1. Response to Reviewer 1 (Mario Rohrer)

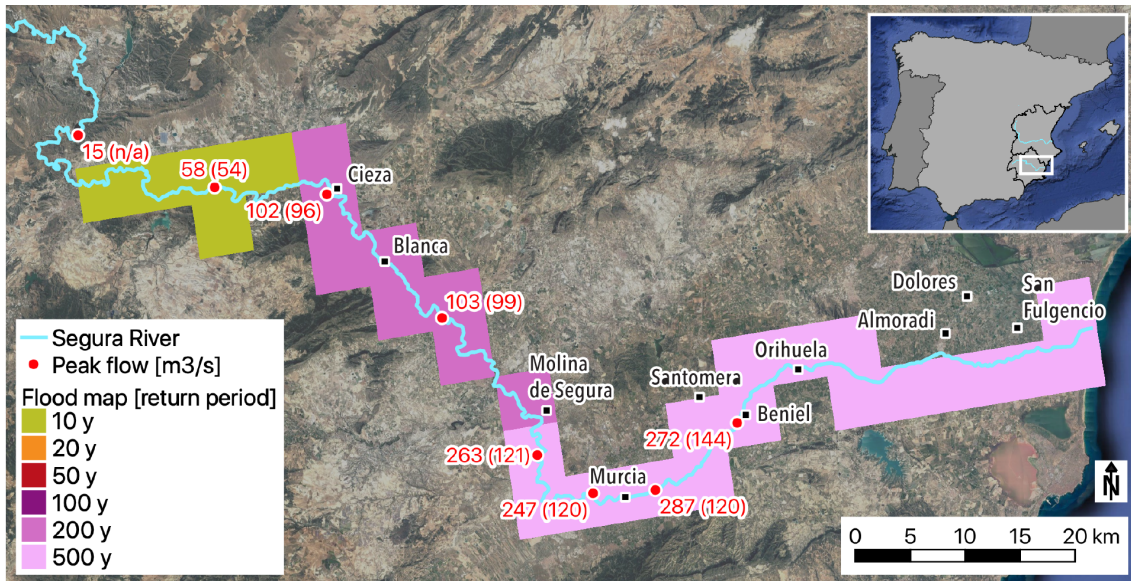
- 1.6. *Fig. 2. Concerning the legend: I suppose the colors are representing the RETURN PERIOD! If this is the case, please write it! This is a very nice figure, but I don't see how the reader can compare the return period at a gauging station with a peak flow runoff in m3/s. Perhaps you can calculate a return period of the runoff gauges, if not, perhaps you can indicate the rank of the runoff, or a similar metric which is in a way comparable to a return period.*

We have added to the legend of Figure 2 the missing term "return period".

The selection of the EFAS flood maps along the Segura is based on comparing the measured peak flows to the input discharges used for the hydraulic simulations of the flood maps (see lines 152-155). To make this connection clearer, we have added to the labels of the stream gauges in Figure 2 the discharges that were used as input for the hydraulic simulation of the selected flood map. The caption of the Figure has been adjusted accordingly:
